Profile Park Power Plant
Planning Application SD21A/0167
Response to Request of Further Information

Response to Request of Further Information

Document Control Sheet	
Document Reference	11069-D02
Report Status	Issue Copy
Report Date	March 2022
Current Revision	D01
Client:	GREENER IDEAS LIMITED
Client Address:	C/O Centrica Business Solutions, 1 Seapoint Building, 44-45 Clontarf Road, Dublin 3, D03 F4A7
Project Number	11069

Figure 3-1: Revised Digital Surface Model (DSM) Visibility map using the lower stack and engine hall heights

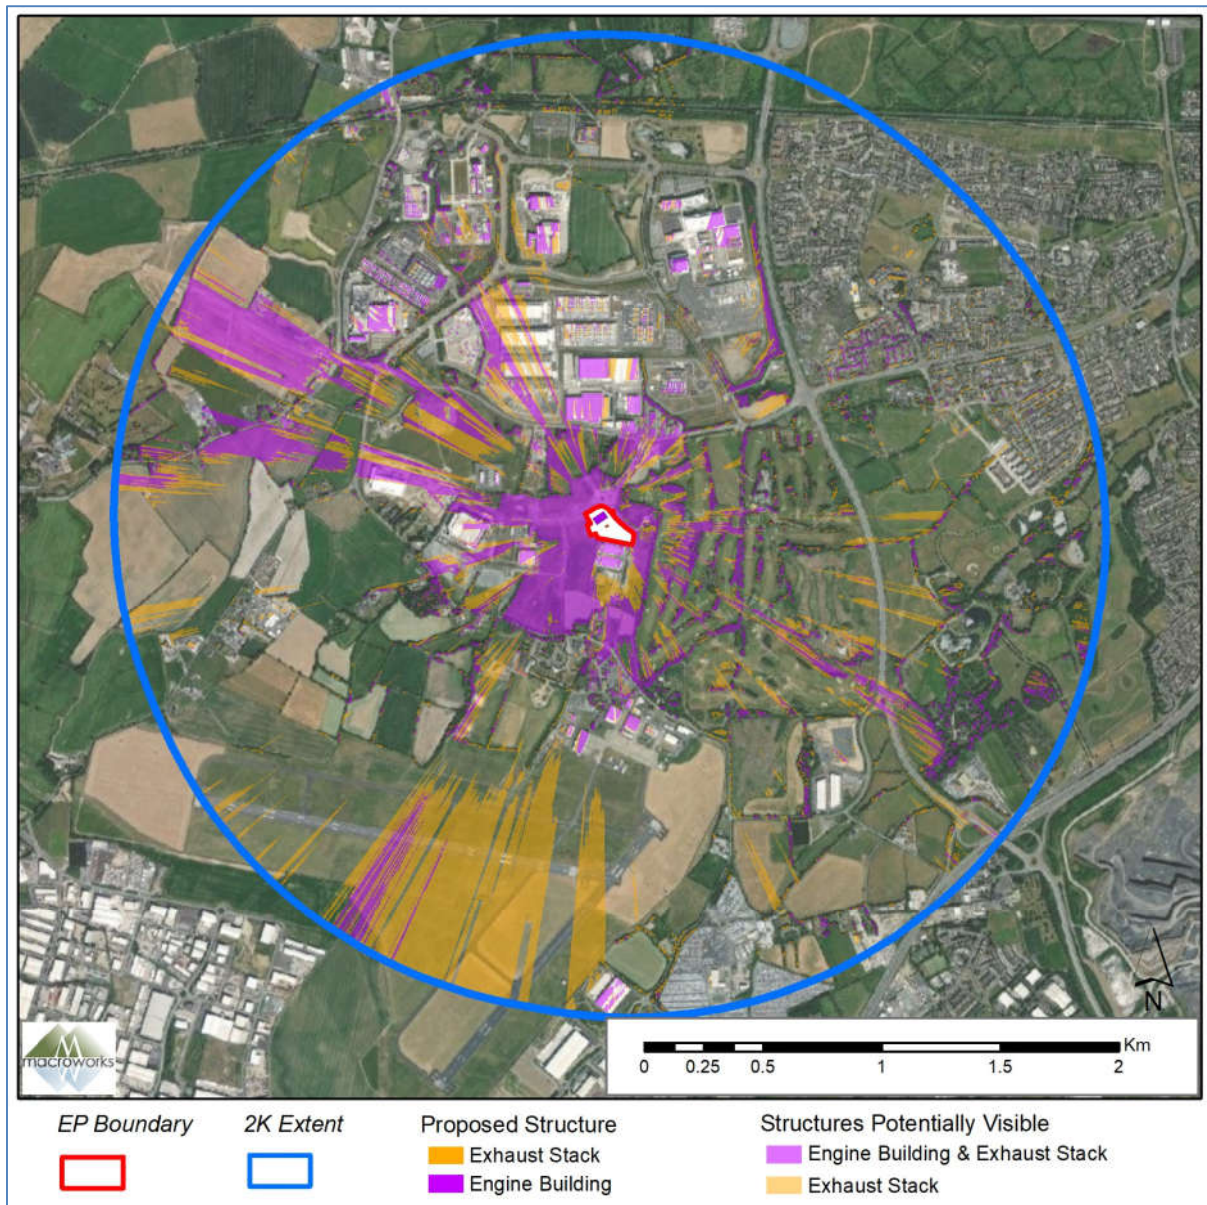
- iv. Scale and height of the stacks. These are extremely prominent and are encased in a structure for the most part. The stacks are significantly taller than all surrounding structures. The applicant is requested to reduce the height and bulk of the structures. The Planning Authority would welcome a height of no more than 25m.

The Zone of Theoretical Visibility (ZTV) mapping has been revised to reflect the reduction in height of the proposed Engine Hall from 18.5m down to 15.5m and the reduction in stack height from 31.8 down to 28m. The revised ZTV map is presented in Figure 1.1 below, and although it appears almost identical to the original ZTV map pattern as presented in the Landscape and Visual Impact Assessment contained in the EIA Report, the statistical variation equates to a 4.5% reduction in visibility for the revised stacks within the study area and a 3% reduction for the revised engine hall.

The main method of response to RFI Item 2 will be the comparative assessment of visual impacts from each of the original LVIA viewpoint locations. The assessment will follow the same methodology as outlined in the original LVIA, but in an abbreviated form (see Table 3.1) as it is not necessary, for example, to redescribe the existing view or attribute sensitivity again. Furthermore, the focus will be on the change in residual (post-mitigation establishment) visual impacts as opposed to changes in pre-mitigation effects.

Figure 5-1: Typical Cross Section of an infiltration permeable paving (Extract from CIRA SuDs Manual)

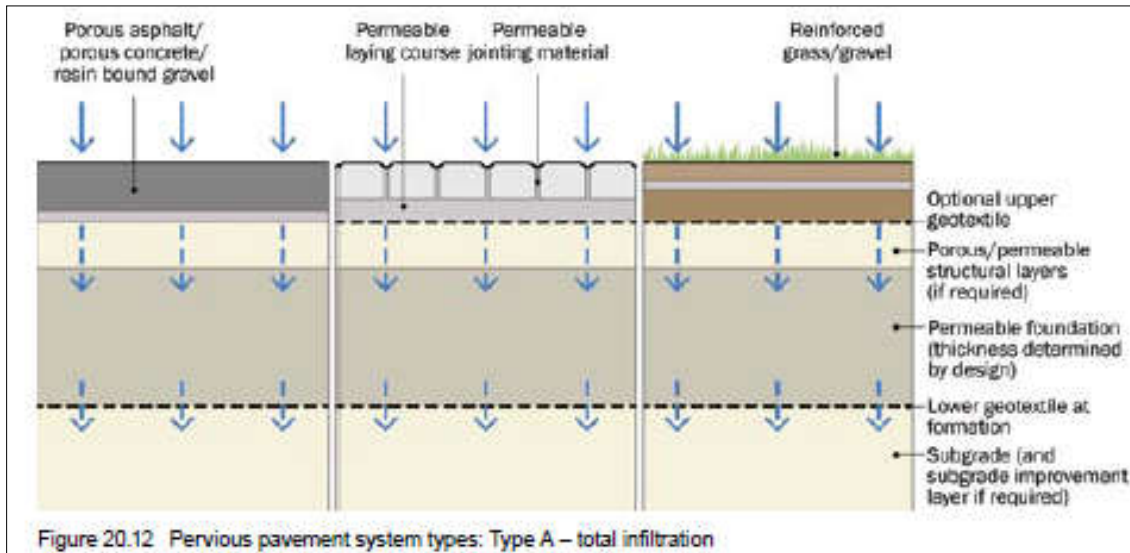
- b) The applicant is requested to submit a cross section detail of all proposed Sustainable Drainage (SuDS) features for the development ie. Grasscrete, Swales permeable paving, infiltration basins etc. The applicant shall also examine whether there is potential to include further SuDS features across the site such as detention basins, further swales, filter drains etc.**

It is proposed to install permeable Grasscrete within the parking areas of the site. The water once permeated into the pavement will be allowed to infiltrate into the ground. The inclusion of the permeable paving will slow the surface water to be treated on site and provide storage. Refer to *Figure 5-1*.

Drawing No.: **Figure 12.2**

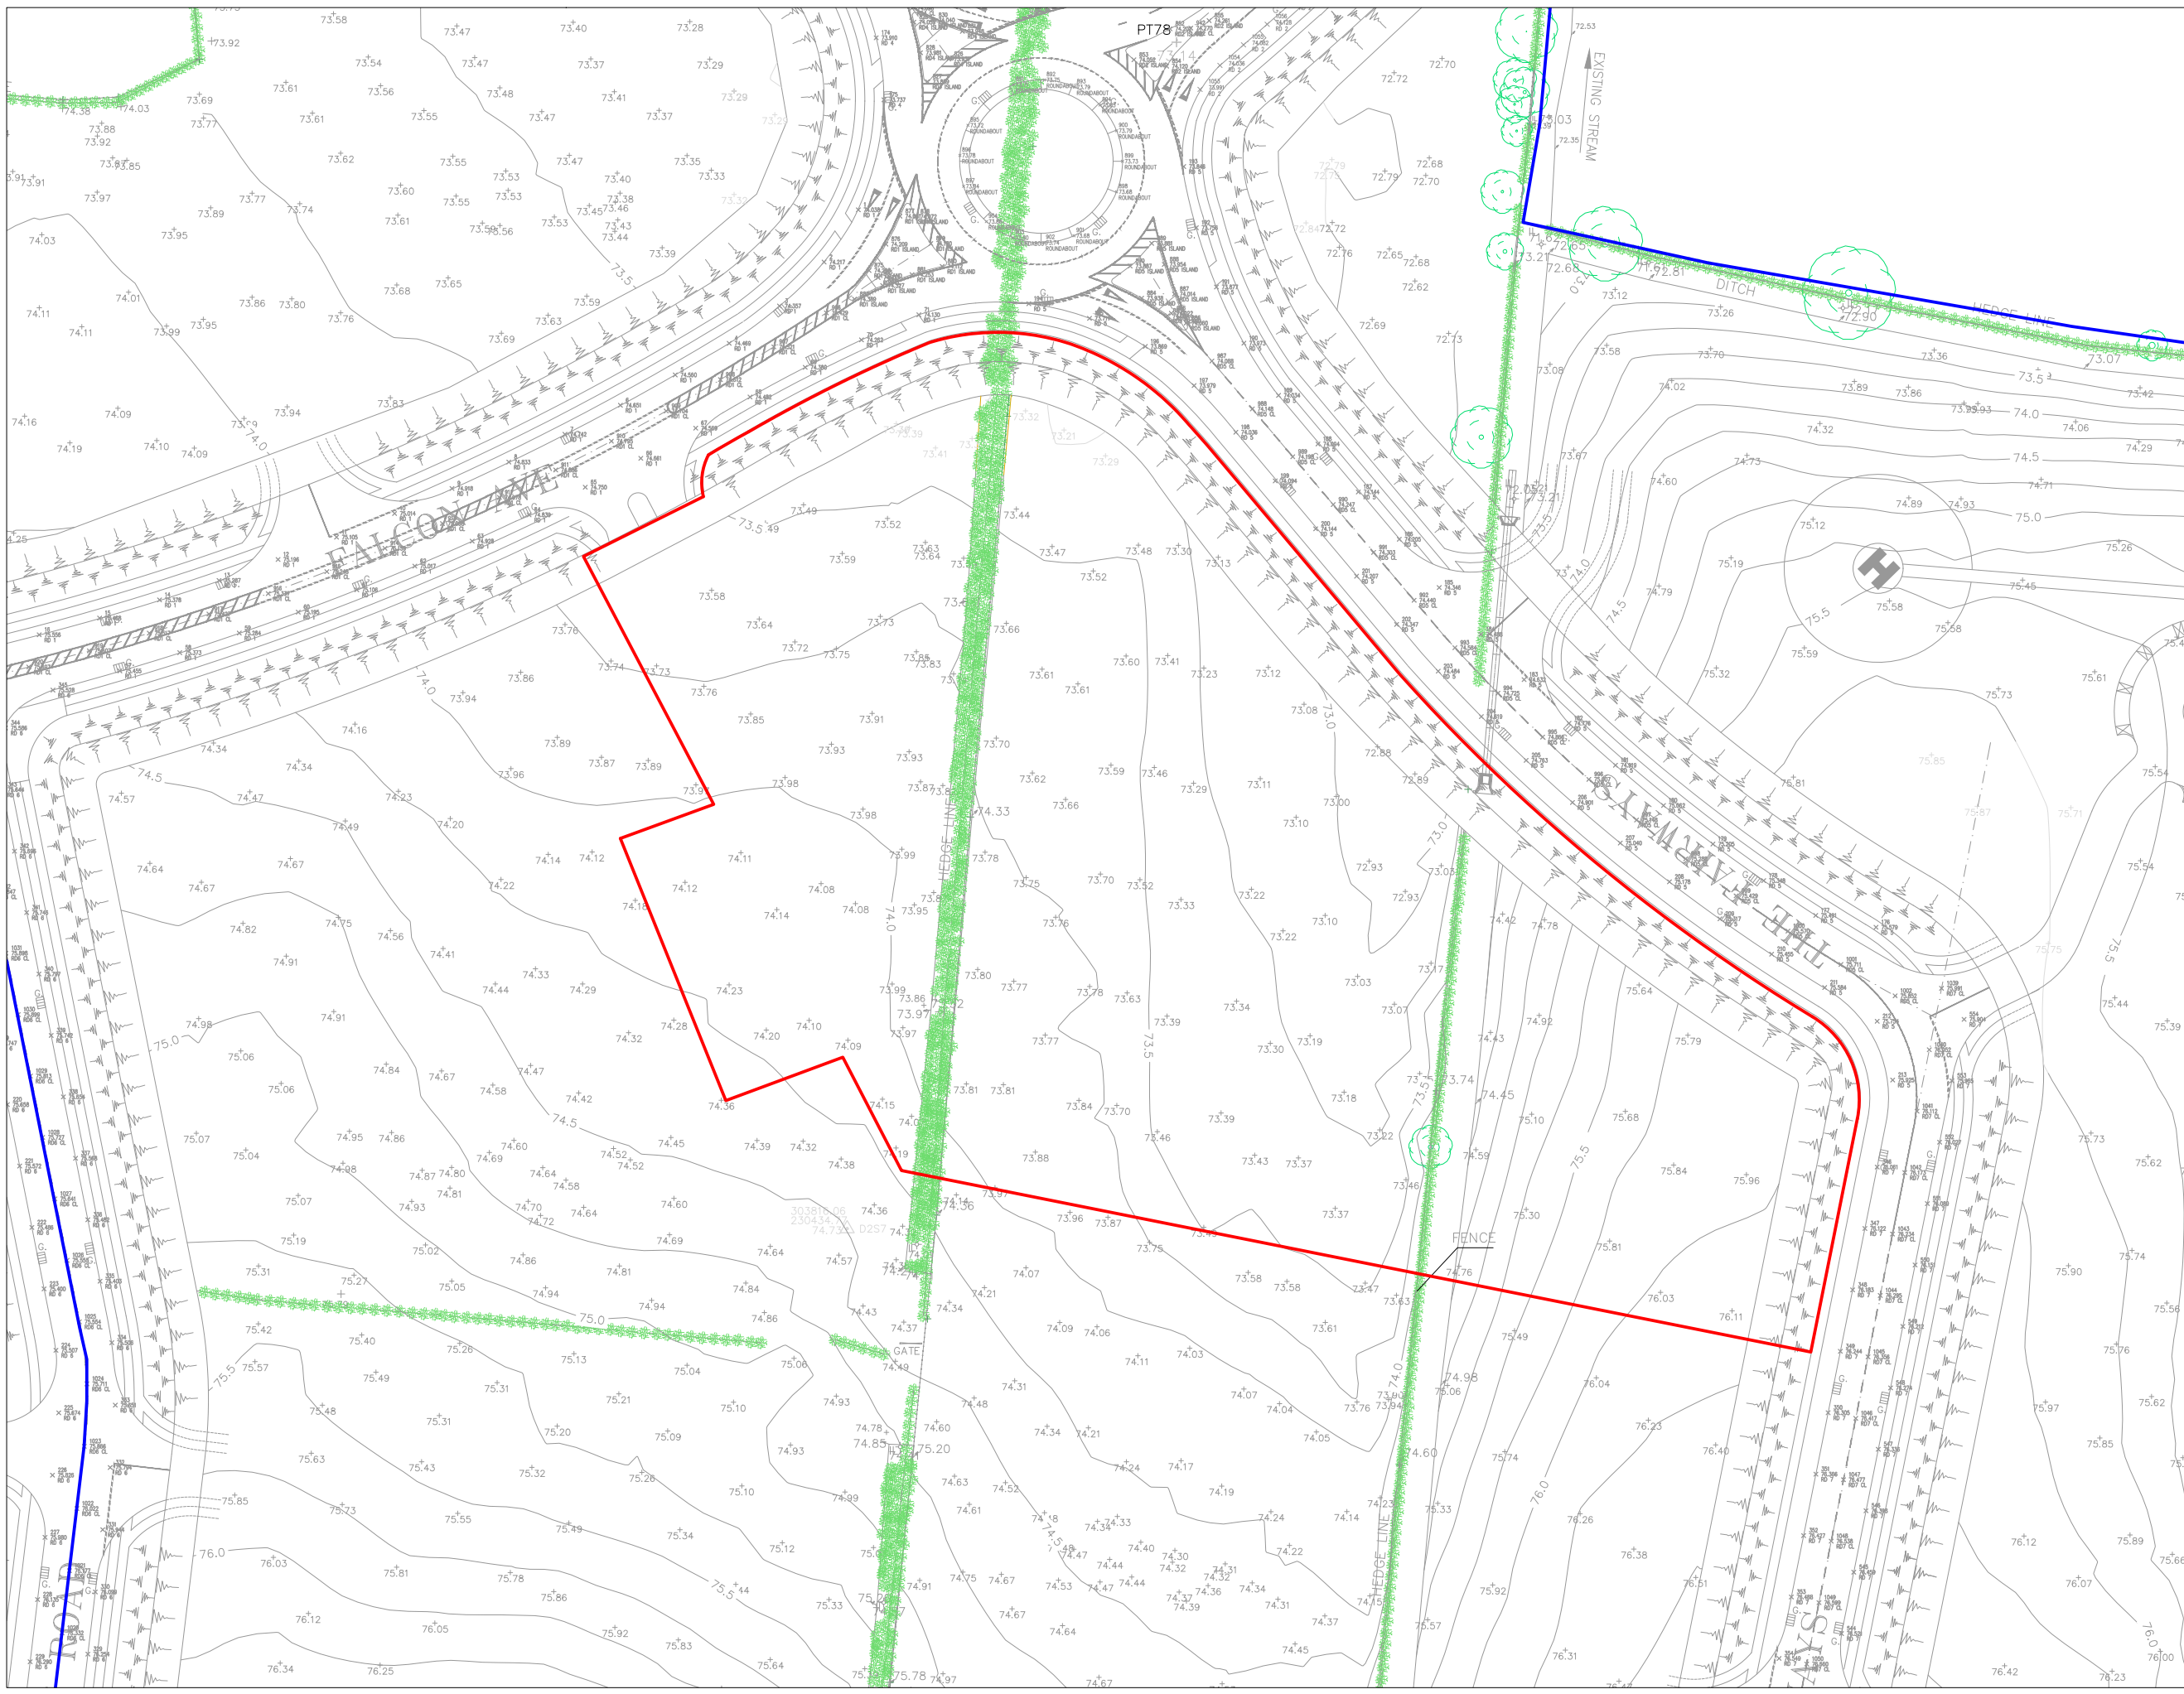
b) The applicant is also requested to provide an existing layout plan, indicating all natural features present.

Figure 11.2 which was provided in Chapter 12 (Biodiversity) of the EIA Report originally submitted to SDCC is reproduced in this report in Appendix 4. This figure shows the existing habitats / natural features on the site of the proposed power plant. These include:

- Wet grassland (dominant habitat on site);
- Hedgerow (i.e. on fence line associated with neighbouring data centre); and
- Eroding/Upland river (i.e. Baldonnel Stream).
